P5024A-03B-S

# Safety Service Note

## P5024A Keysight Streamline USB Vector Network Analyzer

“POTENTIAL BURN INJURY (HIGH TEMPERATURE) HAZARD”

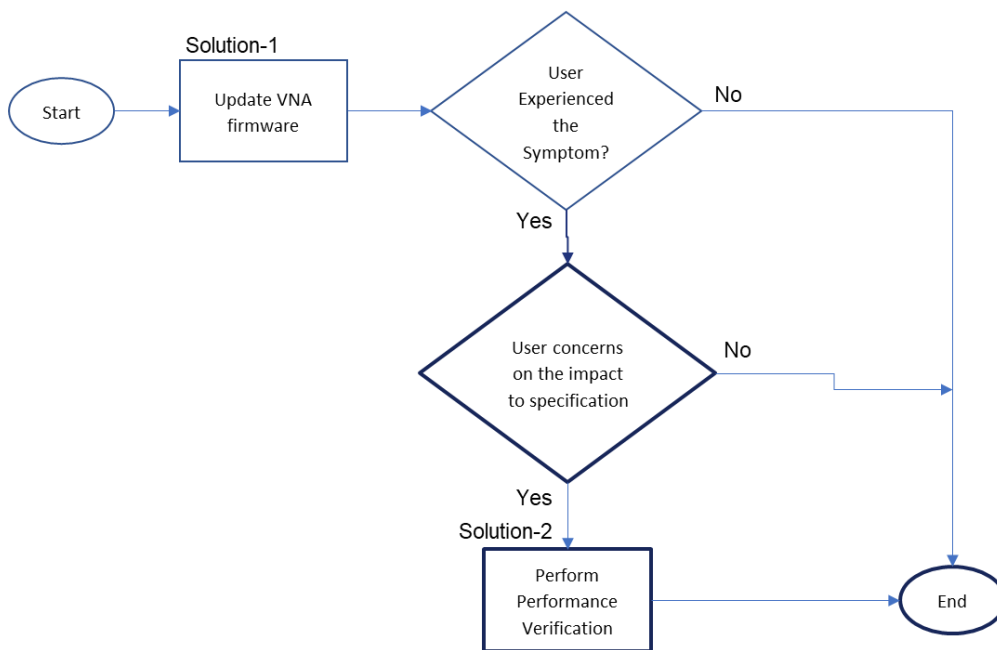
VNA fails to start with the following symptoms.

- 1. LED indicator (below circle) turns red.
- 2. cooling fan does not work
- 3. If user leaves the VNA with this LED indicator red without turning off power switch, it continues to overheat and becomes too hot.

Solution-1: Update VNA firmware by user

Solution-2: Perform Performance Verification by Keysight

1. **Install the latest VNA firmware Rev. A.15.40.13 or newer** on users' controller PC(s).  
The latest firmware enhanced the thermal fan control mechanism.
2. Once the latest firmware is installed, proceed with the restart of both **controller PC** and **VNA**.
3. Launch the VNA firmware. Ensure VNA powers up and launches into firmware correctly after firmware update is done.
